**Planning Commission
Staff Report**

February 26, 2014
Item 6.a.

- SUBJECT:** PUD-103/P14-0086
- APPLICANTS:** SummerHill Apartment Communities
- PROPERTY OWNER:** Las Positas Property, LLC
- PURPOSE:** Applications for: 1) Planned Unit Development (PUD) development plan to demolish the existing office building and construct 177 apartment units and related site improvements on a 5.9-acre site, and 2) Development Agreement to vest the entitlements for the project.

- GENERAL PLAN:** Mixed Use/Business Park
- ZONING:** Planned Unit Development – Mixed Use (PUD-MU)
- LOCATION:** 5850 West Las Positas Boulevard
- EXHIBITS:**

Fig. 1 -- Proposed Site Plan

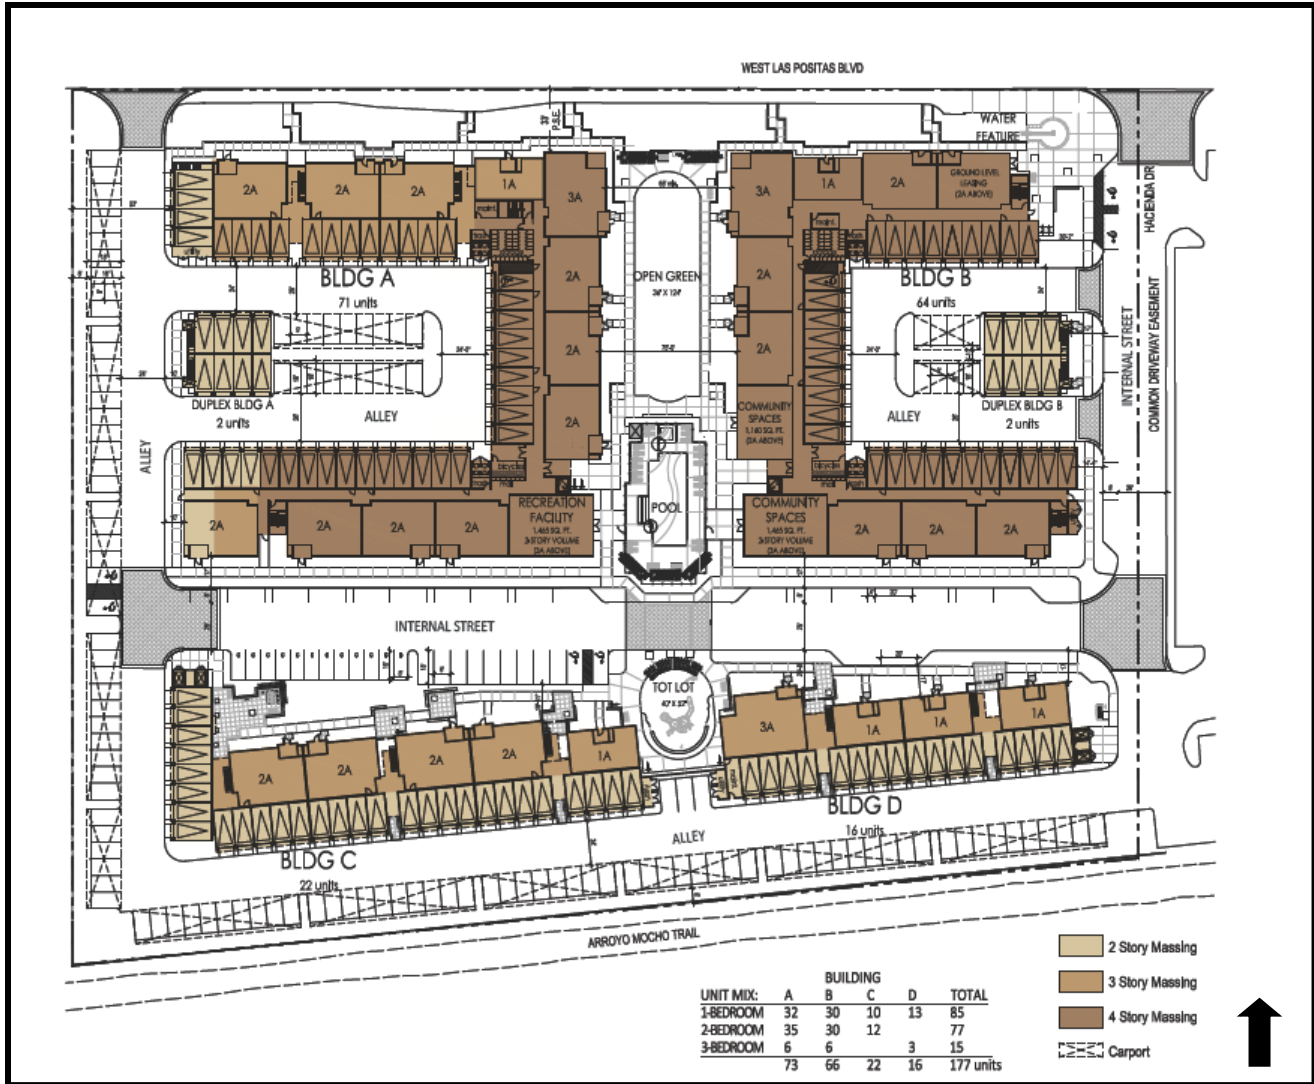
Comments: The applicant could remove carport parking along the western property line and still conform to the requirement of providing one covered parking space per

residential unit. The applicant prefers to keep the carports as the carports have been considered as a amenity to the apartment tenants. The Planning Commission indicated that they would support this exception if the adjoining property owner to the west, Chamberlin Associates, supported the carport location. One commissioner asked about relocating some of the carport elsewhere on the project site so as to break up the carport presence along the westerly property line. Chamberlin and Associates and the applicant have reached a compromise on this item. It is agreed between them to have two small carports located along the westerly property line. The parties have also agreed that the design of the carports will match the design of the building. Staff supports this revision, provided that the carport dimensions and designs be reviewed and approved by the Director of Community Development.

2. The existing western entrance would serve as one of the two entrances to the proposed development. It should, like the eastern entrance, be designed as an internal street. Sheet A1.2 shows it is designed as an alley.
